INDIANA DEPARTMENT OF ENVIRONMENTAL MANAGEMENT

Re: Confined Feeding Operation
Approval Renewal
Reauthorization of Construction
Approval Facility Change
Top Grade Production LLC
Howard County
Farm ID #3713
Animal Waste Number AW-6822

TOP GRADE PRODUCTION LLC
 2667 EAST STATE ROAD 18
 KOKOMO, INDIANA 46901
 2024 CFO RENEWAL-#3713

TOP GRADE PRODUCTION LLC 2667 E STATE ROAD 18 KOKOMO, INDIANA 46901 2024 CFO RENEWAL-#3713	FARROWING BUILDING FOUNDATION PLAN BUILDING 9P	DATE: 05/10/24 DRAWN BY: MV	SHEET: 2C of 8C	DRAWING NO: TGP0224-02C
---	--	--------------------------------	-----------------	-------------------------

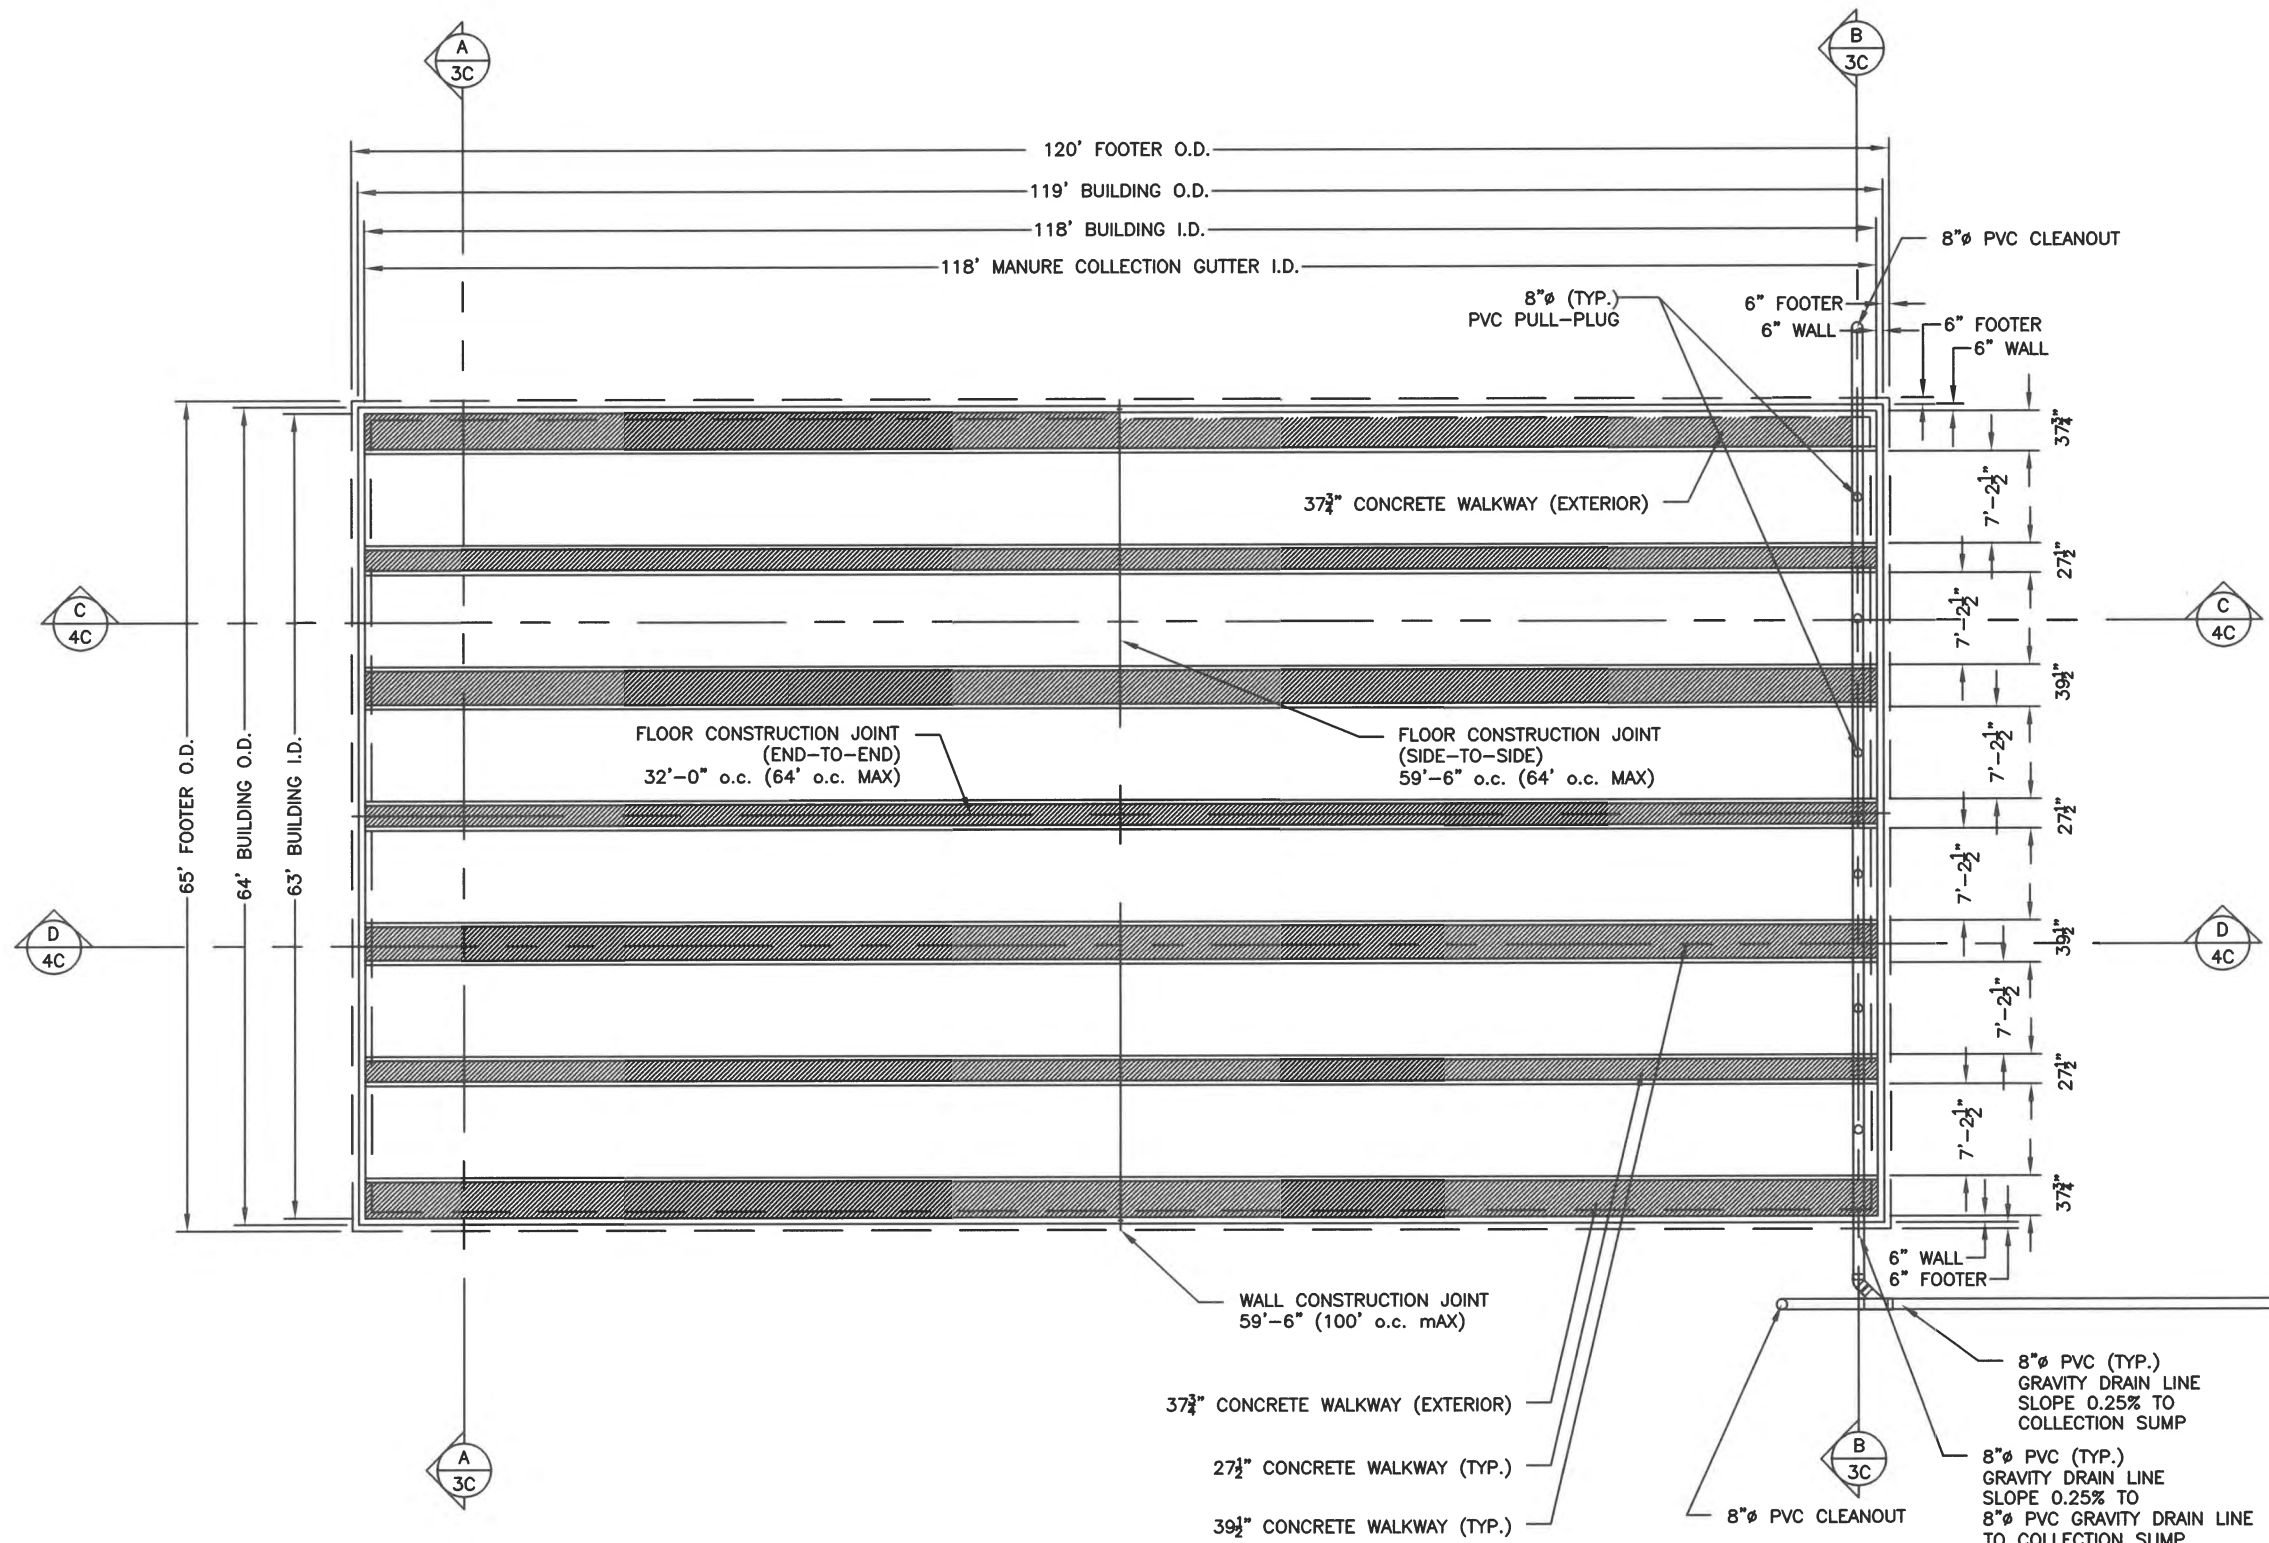
On behalf of Top Grade Production LLC, Livestock Engineering Solutions, Inc. submits the following information. A recent review identified that the building coordinates for Building 9P were incorrectly transcribed on farmstead plan sheet 2A and plan sheet 2C.

The coordinates have been updated on plan sheets 2A and 2C. Updated copies are included. Please replace the previously submitted plan sheets to update the application packet.
